ENGINE - FAN CASE FIRE RAIL AND ECS SENSE LINE WITH MODIFIED BRACKETS - CATEGORY CODE
6 - MOD.ENG-72-0287

V2500-ENG-72-0287

SERVICE BULLETIN

View looking forward on gearbox - Before and after alteration
Fig.1

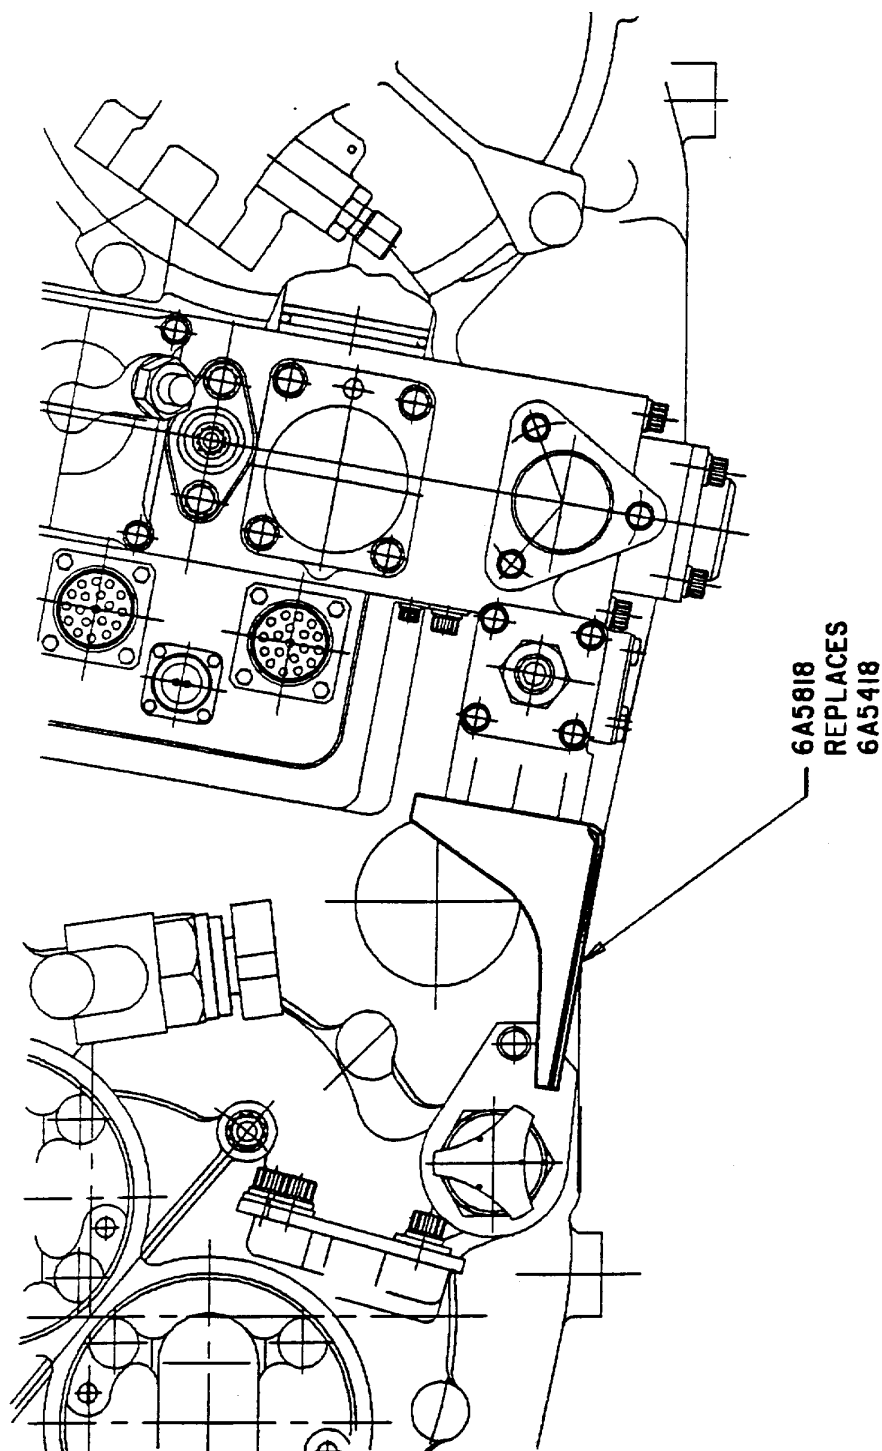
- (1) To make the support of the fire detection rail better, three brackets have been changed. Two of the brackets are installed on the case of the gearbox. The other is installed on the flange for the HP-fuel servo tube and FMU. The changes are as follows:
 - (a) The material of the brackets has been changed from titanium (TAK) to stainless steel (EBM).
 - (b) To increase the area of the support, the length of the brackets installed to the gearbox have increased.
 - (c) The bend radius of one of the brackets installed to the gearbox, has increased.
 - (d) The contour of the web of the two remaining brackets has increased.
- (2) The stub-bracket installed at bolt holes 10 and 11 of flange FN of the LP turbine has changed. To give additional clearance between the bracket and the ECS line, the length of the mating flange has increased.

View looking forward on flange FN - Before and after alteration
Fig.4

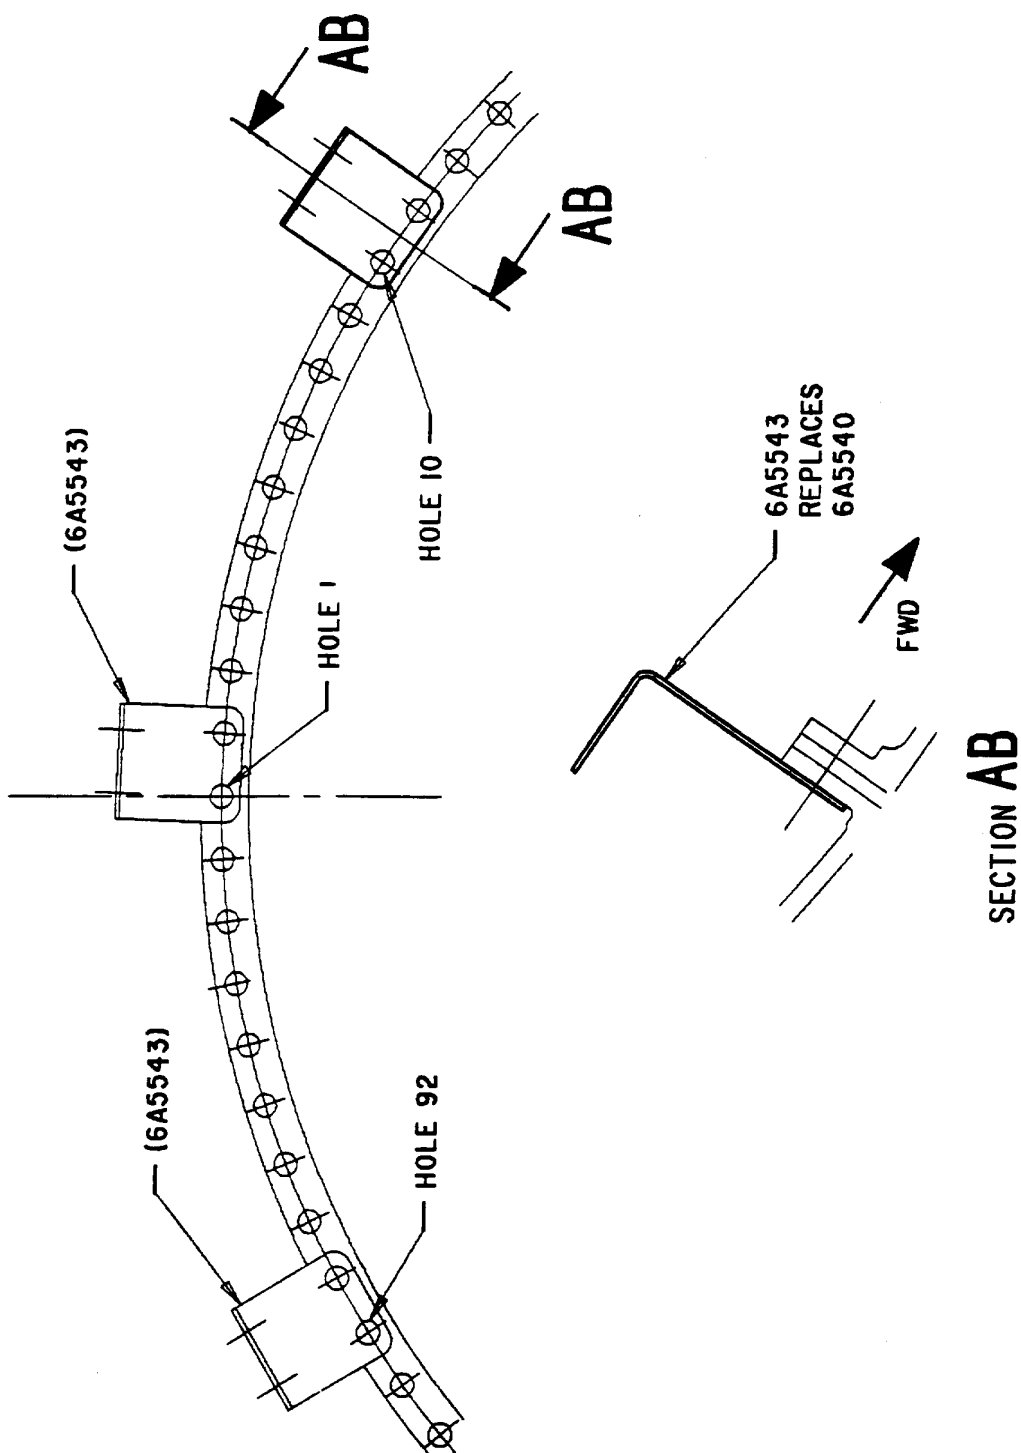
- (b) Also, the clearance between the ECS line and a stub-bracket installed at bolt holes 10 and 11 of the LP-turbine FN flange, is not sufficient.

The problem is caused by the route of the ECS line. To increase the clearance, a change to the bracket is necessary.
